Technical Memo

Proposed Plan Change 14 to the Waipa District Plan

Stormwater Response to Matters Raised by the Henmar Trust in its Statement of Evidence and Legal Submission

Fonterra Limited

Table 1 – Comparison of Pre and Post-development Flood Depth on the Henmar Trust Land
 Image Sources – Appendix 1 to the Stormwater Management Plan (SMP) report

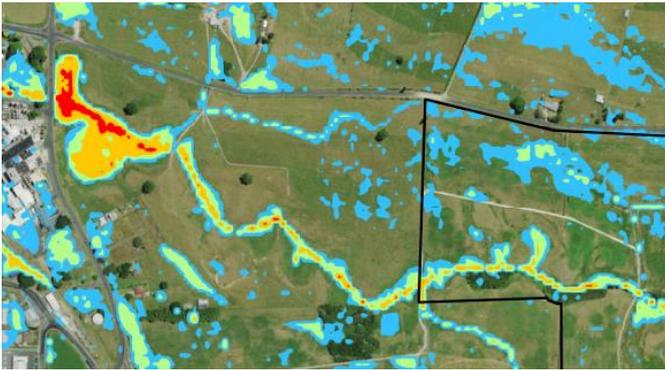
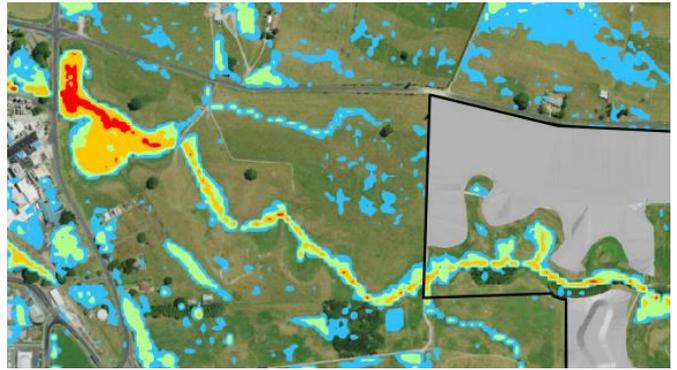
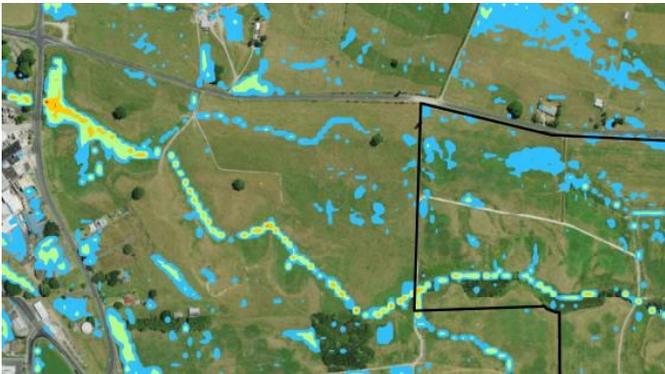
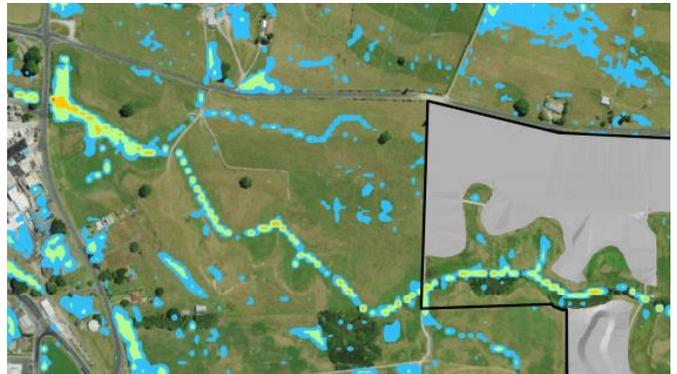
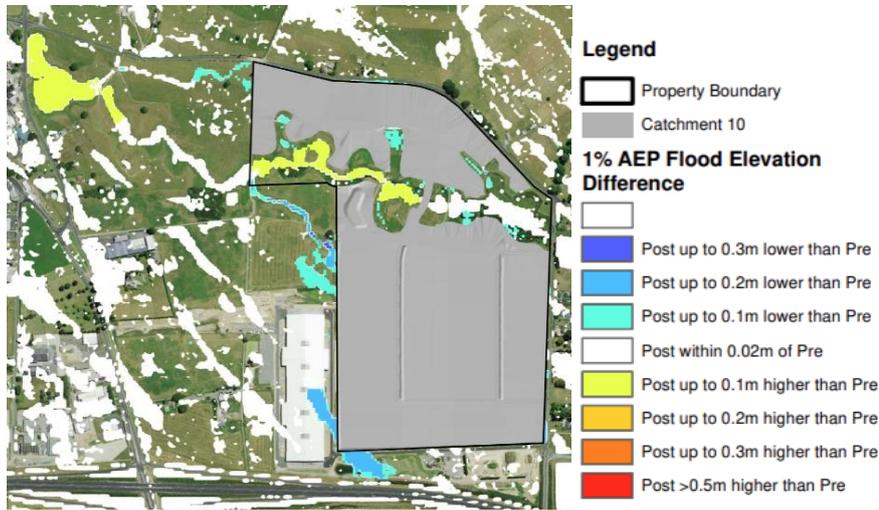
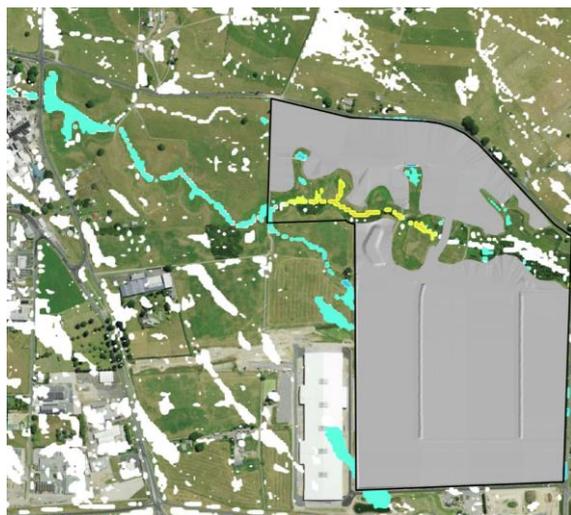
Henmar Trust has raised concerns that the flood effects on its landholding as a result of future industrial development of the PC14 area will not be mitigated. Henmar Trust states (at paragraph 90 of the Statement of Evidence by M L Bourke) that:

“It is imperative that any development upstream of the Henmar Trust property controls their stormwater runoff within their boundaries so that it does not exceed pre-development levels, to avoid further adverse flooding effects on the Henmar Trust property”.

At paragraph 91 of the Statement of Evidence by M L Bourke, Henmar Trust states that:

“The Stormwater Management Plan prepared by Harrison Grierson dated 12 April 2024 (Stormwater Plan) illustrates an increase in downstream flooding on the Henmar Trust property from development on the Mangaone Precinct alone”.

We note paragraph 29 of the legal submission on behalf of Henmar Trust, which states that:

“Pages 17-24 of the Harrison Grierson Stormwater Management Plan document dated 12 April 2024 need to be considered carefully. (Pages available in hard copy) The report on the hydraulic modelling predictions relies on the impact just upstream of the Victoria Road culvert being at a low level of increased flooding i.e low level of increased height of flood waters, but figures 13, 14 and 15 show substantial increase in the areas flooded in comparison with the pre-development flooding effects. Figure 13 shows a substantial area of the Henmar Trust property receiving post-development flooding up to 0.1 metres (100mm) higher than pre-development. A small but still significant area of increased flooding up to 0.1 metres higher is shown in figure 14 for the 10% AEP storm event. Even the flood level difference shown for the 50% AEP storm event in figure 15 is a material increase in flooding up to 0.1 metres.”

- In the 1% AEP storm event, there is a very slight increase in flood level in the northwest corner of the Henmar Trust landholding, immediately upstream of the Victoria Road culvert. The area affected by the increased flood level is very small (represented by an almost indiscernible increase in the area of red shading in Table 1 above) and is wholly contained within the extent of the pre and post-development flood plain area. We note that the extent of the flood plain does not increase in the post-development scenario.

- As confirmed in Table 9 of the Stormwater Management Plan (SMP) report prepared by HG, the increase in flood level upstream of the Victoria Road culvert is a maximum of 20mm in the 1% AEP storm. It is important to note that the flood level difference maps, presented in Table 2 above and Figures 13-15 of the SMP report, categorise the flood levels such that any increase between 20mm and 100mm is presented in a single category. However, the actual level rise upstream of the Victoria Road culvert is within the 20-25mm range, as discussed on page 21 of the SMP report. Moreover, the extent of the flood remained unchanged between the pre-development and post-development scenarios, given the extensive existing storage area upstream of the Victoria Road culvert.

- In the 10% and 50% AEP storm events, there is no increase in flood level or extent in the post-development scenario when compared to the pre-development scenario and, in some locations modelled, there will be a reduction in flood level.

To clarify in this regard, Figure 13 does indeed show a very slight increase in flood level within the Henmar Trust Land in the 1% AEP storm event (as discussed above, the actual increase in the flood level is between 20mm and 25mm). However, Figure 13 needs to be considered alongside the flood depth maps at Appendix 1 of the SMP report (refer also **Table 1** above); together, Figure 13 and the Appendix 1 maps confirm that, despite an actual increase of between 20mm and 25mm in flood level immediately upstream of the Victoria Road culvert, there will be no increase in the spatial extent of flooding with all flows accommodated within the existing flood plain on the Henmar Trust land. Figures 14 and 15 in contrast do not show any increase in flood level or extent in the post-development scenario; rather, they show a reduction in flood depth in the 10% and 50% AEP storm event on the Henmar Trust land.

Having regard to the above, there will be no increase in downstream flood effects on the Henmar Trust land as a result of industrial development of the PC14 area. The flood extent in the post-development scenario will be wholly contained within the flood plain of the Mangaone Stream. Therefore the very slight increase in flood level in the small area identified will not result in an increase in downstream flood effects on the Henmar Trust land based on the modelling undertaken.

FIGURE 1: CATCHMENT AREA OF THE MANGAONE STREAM (THE MANGAONE PRECINCT (PC14 AREA) IS OUTLINED IN RED AND THE PC14 STRUCTURE PLAN AREA IS OUTLINED IN BLACK)

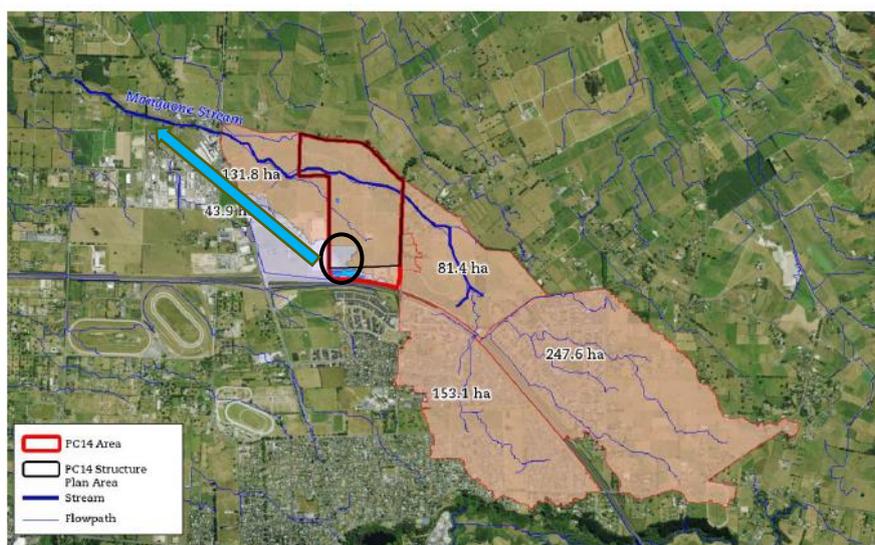
Henmar Trust has noted (at paragraph 94 of the Statement of Evidence by M L Bourke) that the SMP report prepared by HG states that:

“The southwest corner of the PC14 Structure Plan is within another subcatchment that drains into the Mangaone Stream approximately 500 metres downstream from Victoria Road.”

Henmar Trust has queried where the discharge point for this sub-catchment is.

- The sub-catchment within the PC14 area that is noted as draining into the Mangaone Stream approximately 500m downstream from Victoria Road, is shown in Figure 1 of the SMP report (as replicated in **Figure 1** below).
- **Figure 1** identifies the southwest corner of land concerned within the black circle and the blue arrow denotes the general direction that stormwater would have drained from the sub-catchment pre-development of the Bardowie Industrial Precinct Structure Plan area and the PC14 area.

- The developed hydraulic model utilises a 2D rain-on-grid approach to simulate flooding beyond the PC14 area, including the area to the southwest of PC14. In the 2D rain-on-grid model, rainfall is directly applied to the flexible mesh elements (ground surface), allowing runoff to follow the topography and generate overland flow paths. This represents the most natural method for modelling runoff, as the flood loading points (discharge locations) are not manipulated. Thus, any runoff from the relevant catchment flows downstream according to the existing topography.

- The stormwater modelling undertaken for the PC14 area anticipates that levels within the PC14 structural plan area will be modified at the time of industrial development so that stormwater will drain north and east through the network of swales (and the piped network) within the PC14 area towards the stormwater management devices that will be located within the Mangaone Stream Reserve area. Stormwater flows will be attenuated in these devices to manage stormwater discharge to the Mangaone Stream from the PC14 area and ensure that there will be no increase in downstream flood effects on the Henmar Trust land.
